SUBJECT: ISSUANCE OF AMENDMENTS - EDWIN I. HATCH NUCLEAR PLANT,
UNITS 1 AND 2 (TAC NOS. M84629 AND M84630)

SAFETY EVALUATION BY THE OFFICE OF NUCLEAR REACTOR REGULATION
RELATED TO AMENDMENT NO.187 TO FACILITY OPERATING LICENSE DPR-57
AND AMENDMENT NO. 126 TO FACILITY OPERATING LICENSE NPF-5

EDWIN I. HATCH NUCLEAR PLANT, UNITS 1 AND 2

FIGURE 2.1-1
REACTOR VESSEL WATER LEVEL

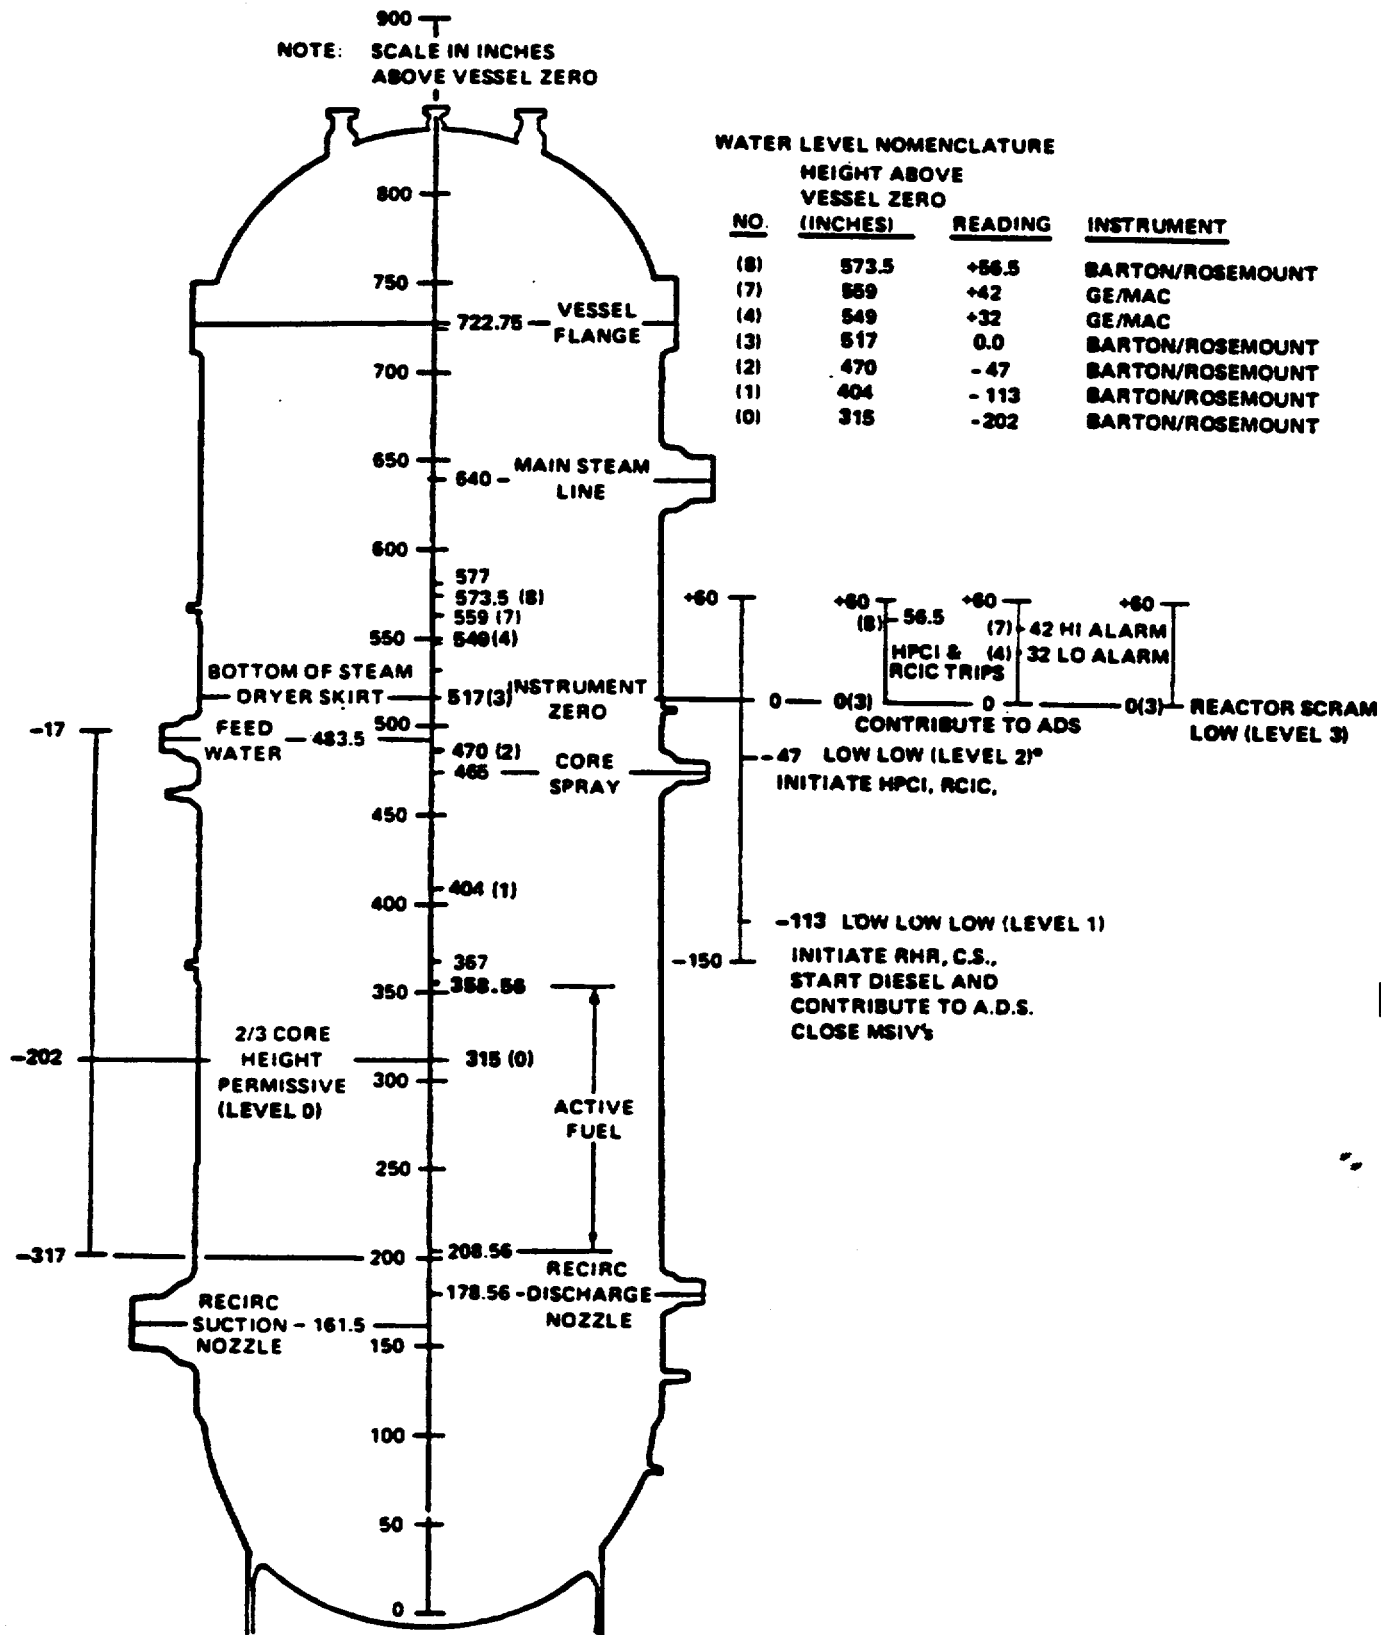
The amendments correct the reactor pressure vessel water level corresponding to the Top of Active Fuel for both units. The correct value is 6 inches higher than the value shown in TS Figure 2.1-1 for Unit 1 and Figure B 3/4 3-1 for Unit 2.

[r]ecently, an error in Unit 1 figure 2.1-1 and Unit 2 figure B 3/4 3-1 TAF notation was discovered. The same incorrect value also appeared in the Unit 1 and Unit 2 FSARS, and plant procedures. The TAF level indicated on the referenced figures (i.e., 352.56 inches) is correct for GE 7x7 fuel design which had a fuel length of 144 inches. However, Plant Hatch no longer uses 7x7 fuel. Subsequent fuel 8x8 designs purchased in the mid-to-late 1980s have maximum active fuel lengths of 150 inches. The top 6 inches of fuel in the 8x8 and newer fuels are made of nonenriched uranium. The TAF value presently referenced in the TS, as well as plant procedures, is still based on 144-inch length fuel and, therefore, should be revised to reflect the actual dimension of later fuel designs.

The licensee also stated that the correct TAF value (358.56 inches) was used in the accident analysis. In addition, the initiating RPV level setpoints for the emergency core cooling systems (ECCSs) assumed in the analysis are much lower (as measured from the bottom of the reactor vessel which is designated as zero) than the actual plant setpoints. Therefore, the use of the incorrect TAF value (i.e., 352.56 inches) did not affect the setpoints for Levels 1, 2, and 3 (corresponding to low-low-low, low-low, and low levels, respectively) or any other aspects of a loss-of-coolant accident analyses.

The licensee has concluded that raising the TAF boundary by 6 inches does not affect or require a change to the accident analysis because the analysis had used the correct fuel length and TAF boundary, and does not involve any physical changes to the plant. Thus, the proposed change will merely bring the TS in agreement with the actual plant configuration.
